Project #221-046 Bull Market Lot 1B Drive-Thru Located at 1375 North Main Street

Project Name: Bull Market Lot 1B Drive-Thru

Submitted By: Tanya Rice, Planner II

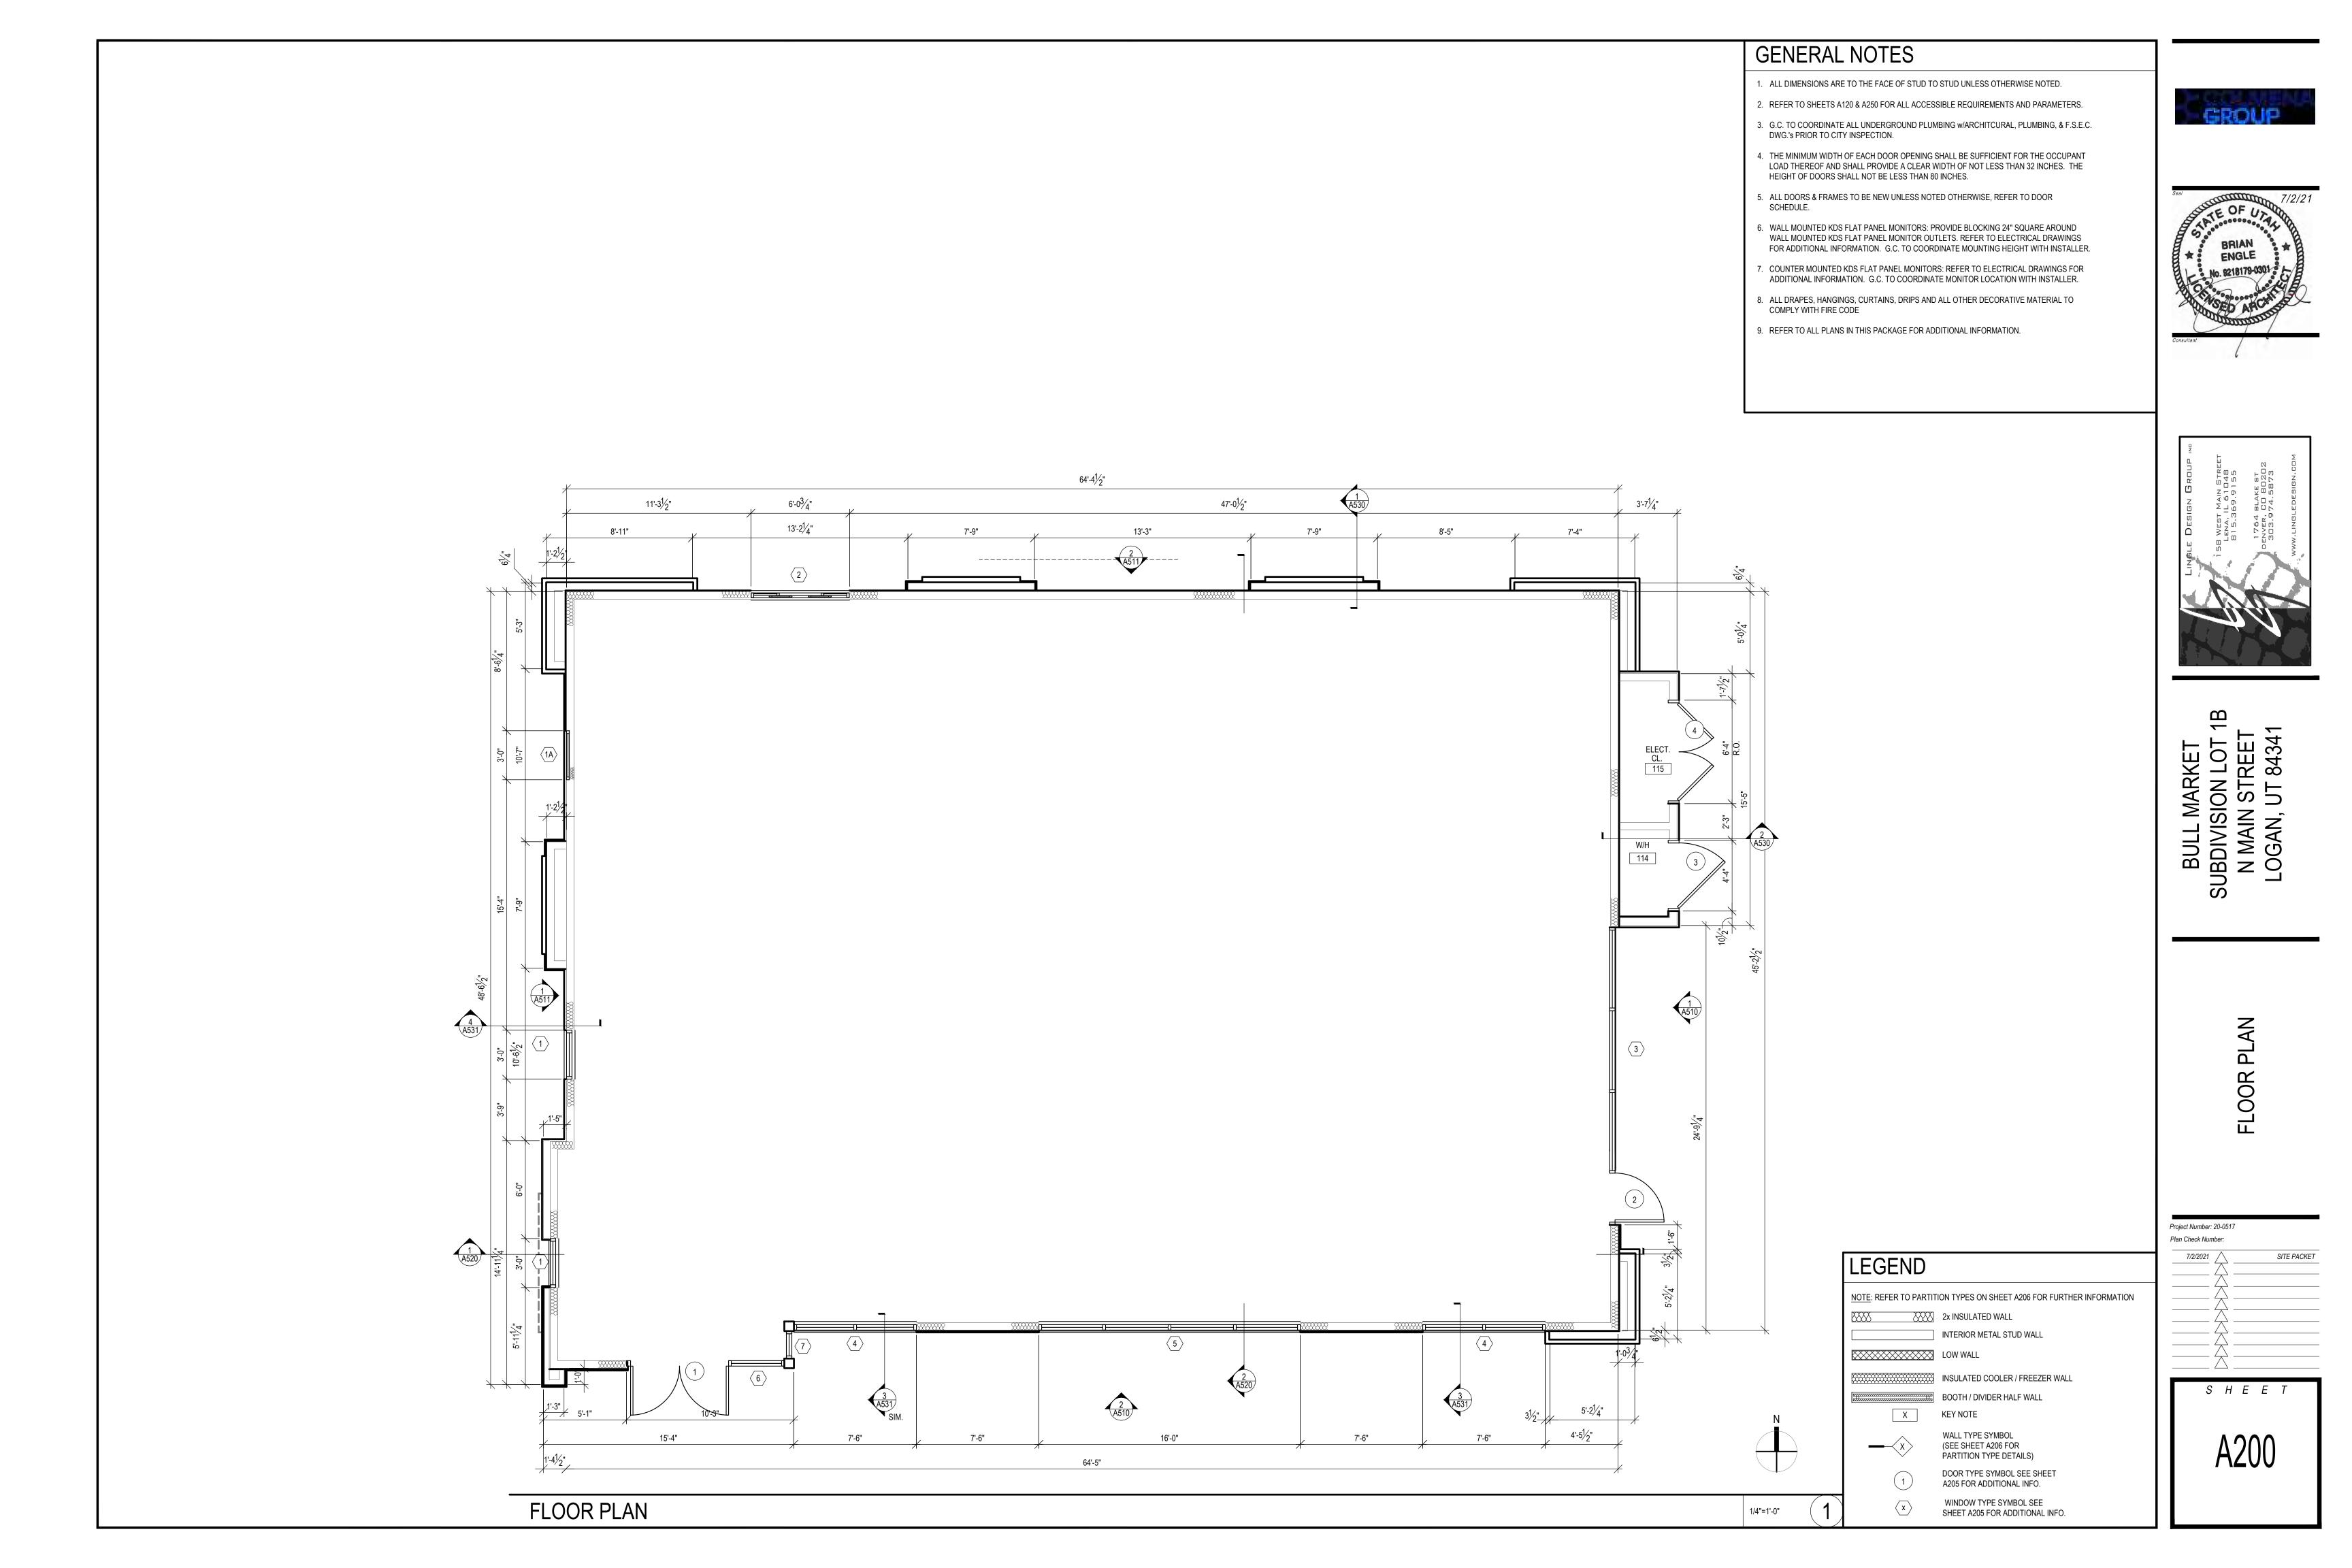
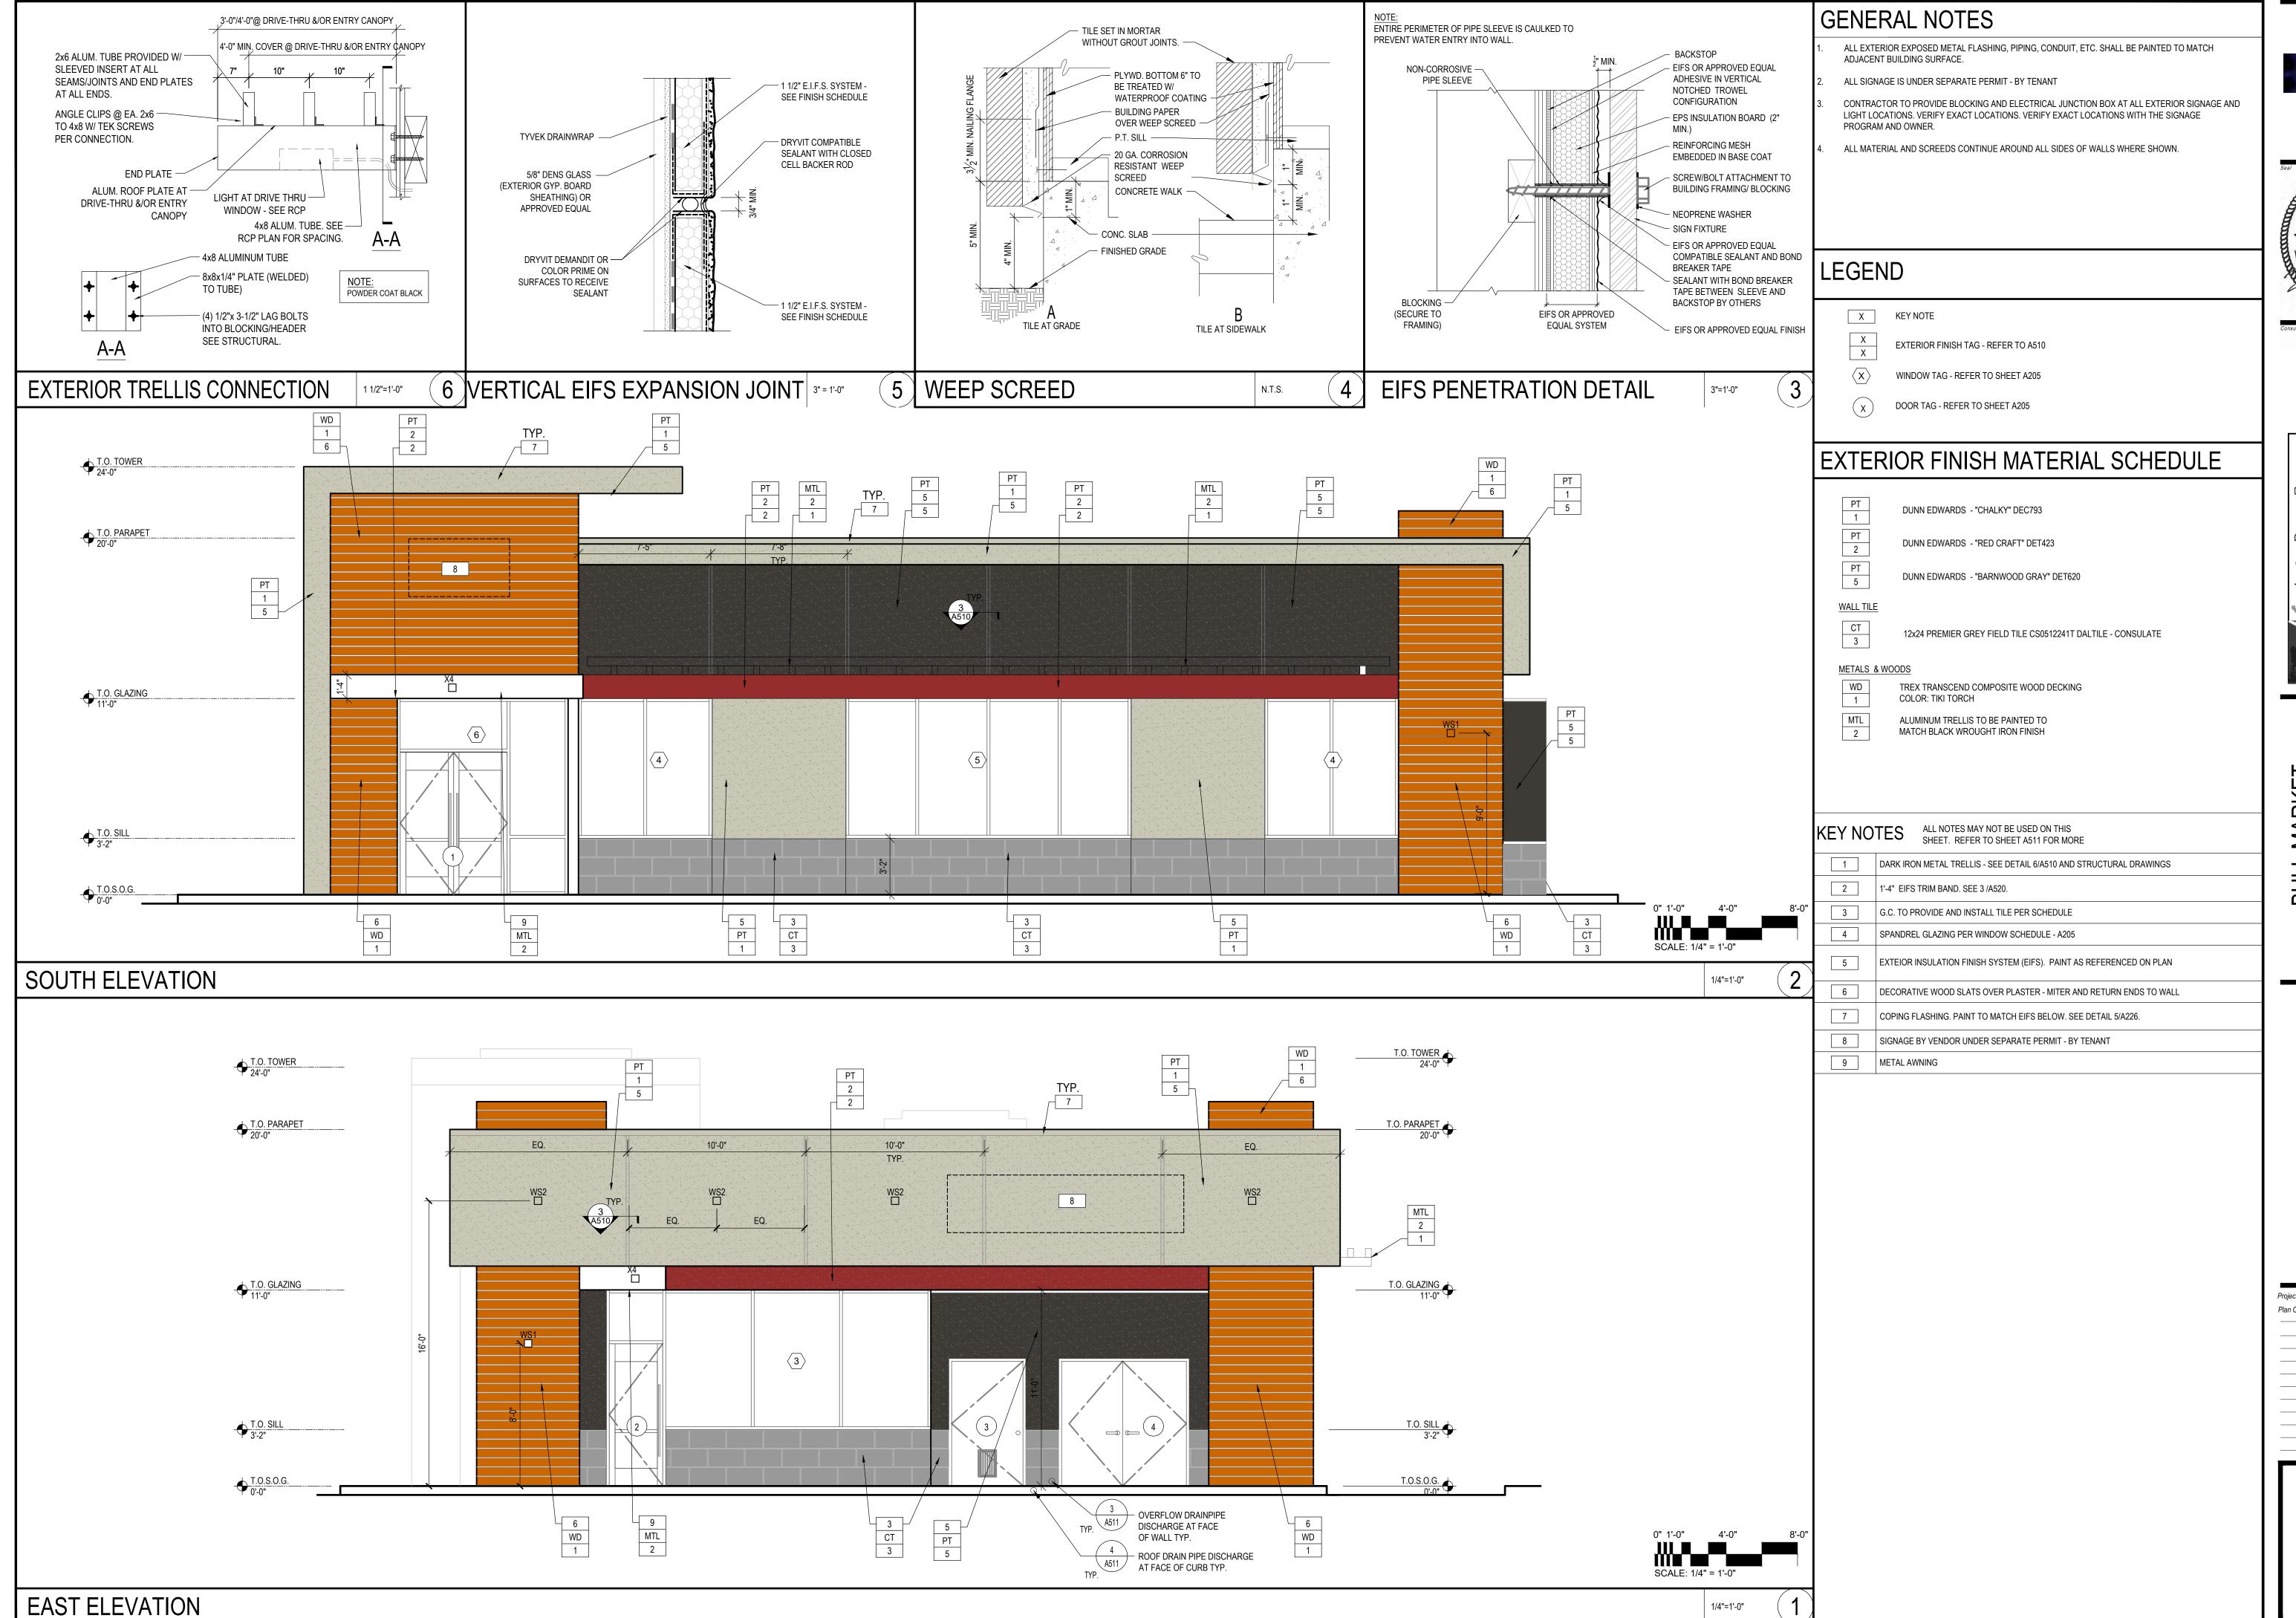
Transparency (fenestration) requirements for commercial buildings in the COM zone is 30% along street facing facades. The east building façade is considered the street facing frontage and includes a grouping of windows, a pedestrian entrance and utility doors. If the utility doors are counted towards fenestration, a metal awning consistent the architectural detailing of the building needs to be added to those doors. As proposed, the east façade contains approximately 26% fenestration which is below the minimum requirement. As conditioned (#4 & #5) with additional street facing fenestration and added awnings to the utility doors, the project meets the LDC requirements.

The LDC 17.12.030 states that building's and primary entrances should be oriented towards the street. In situations where the primary entrance is not oriented towards the street, the street facing façade shall have similar façade treatments/details/style found on the façade containing the primary entrance. The proposal shows the side of the building facing the street with similar architectural style as the primary entrance with outdoor seating and umbrellas. This façade contains windows, awnings, entryways and roof variations. As proposed with similar architectural features found on both the primary entrance facade and the street façade, the project meets the LDC requirements.

- 1. All standard conditions of approval will be recorded with the Design Review and are available in the Community Development Department.
- 2. Bike racks shall be installed for bicycle parking.
- 3. The project shall provide 50% building frontage along Main Street.
- 4. The utility doors with overhead weather protection can be considered as meeting the intent of fenestration for this application.
- 5. The project shall provide 30% street facing transparency/fenestration.
- 6. Weather protection shall be provided above all pedestrian entrances.
- 7. A performance landscaping plan, prepared in accordance with §17.32 of the LDC, shall be submitted for approval to the Community Development Department prior to the issuance of the building permit. The plan shall include the following:
